11683A Range Calibrator

MANUAL IDENTIFICATION

Model Number: HP 11683A

ABOUT THIS SUPPLEMENT

Figure 15. A3 Assembly Component Locations (Part of Change 4)

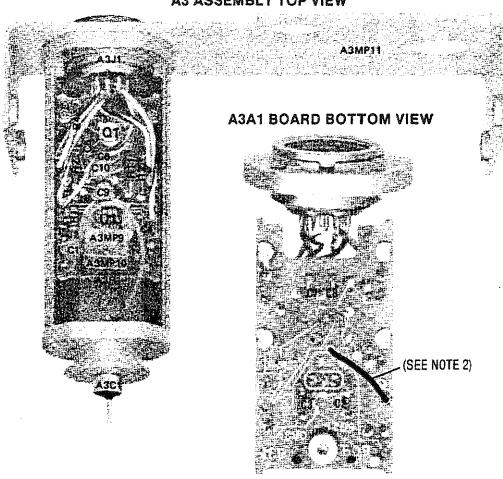
Replace Figure 15 "A3 Assembly Component Locations" with the new Figure 15 in this change sheet. (Change 4)

NOTE 1: A3 COMPONENT REFERENCE DESIGNA-TIONS ARE PRECEDED BY "A3". ALL OTHER COMPONENTS ARE PART OF THE A3A1 BOARD.

NOTE 2: WHEN THE A3A1 ASSEMBLY IS REPLACED AN INSULATED JUMPER WIRE MUST BE ADDED BETWEEN GUARD AND SIGNAL GROUND.

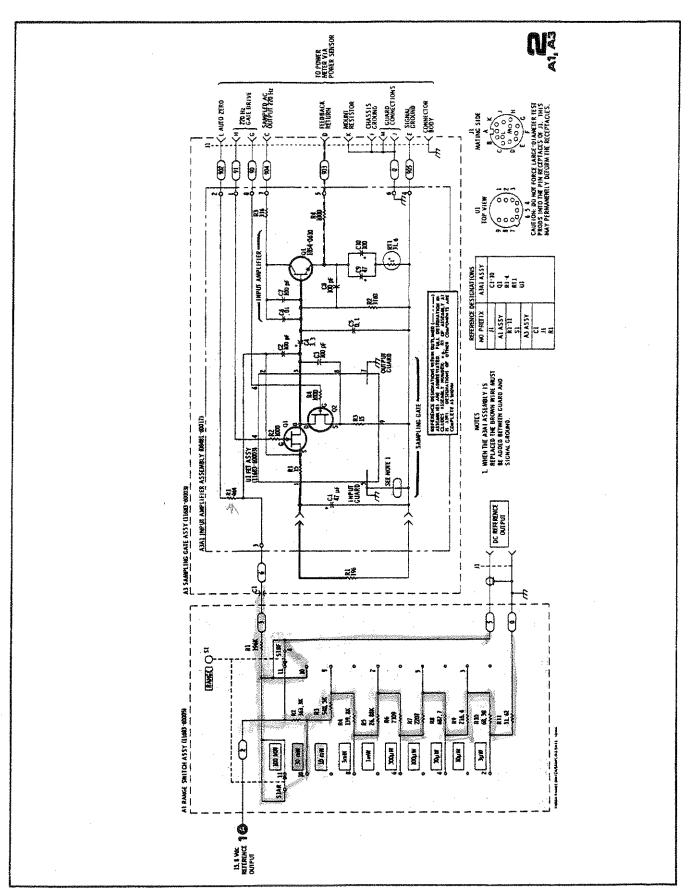
Page 21, Figure 16:

Change the part number of the A3A1 assembly to 08481-60025. (Errata)

Change the value of R1 (left side of A3A1 assembly) to 464k. (Errata)

Delete the connection of C1 to U1 pin 1 (left side of A3A1 assembly). (Errata)

Connect the positive side of C1 to the SOURCE (S) of U1 on the A3A1 assembly. (Errata)

At J1 (right side of schematic) add pin A. Connect pin A to the junction of pins F, M and J. (Change 1)

At J1 (right side of schematic) remove the line connecting pin A to pins F, M and J. (Change 2)

Figure A2. Assembly Component Locations

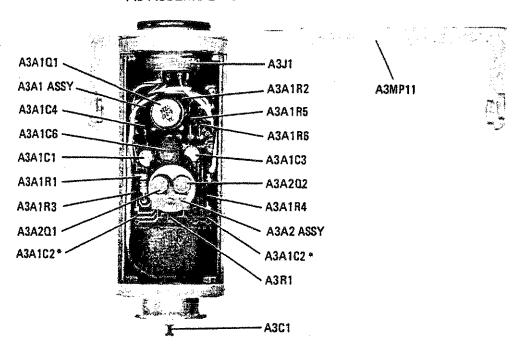
Page 20, Figure 15:

Replace Figure 15 with the one below:

Figure A3. Range Switch/Sampling Gate Schematic Diagram (P/O Figure 18)

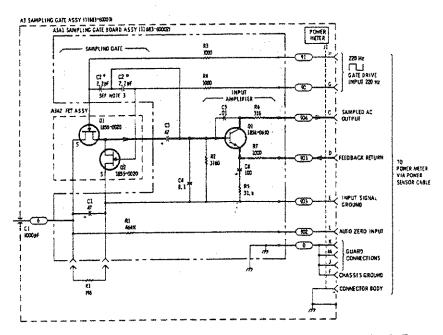
Page 25, Figure A3 (bottom of page):

Add the following notes to Figure A3:

- 1. Reference designations within this assembly are abbreviated. Add assembly number to abbreviation for complete designator.
- 2. Unless otherwise indicated, resistance is in ohms and capacitance in microfarads.
- 3. A capacitor may be found in only one of the two locations shown for A3A1C2 or it will be omitted. (Errata)
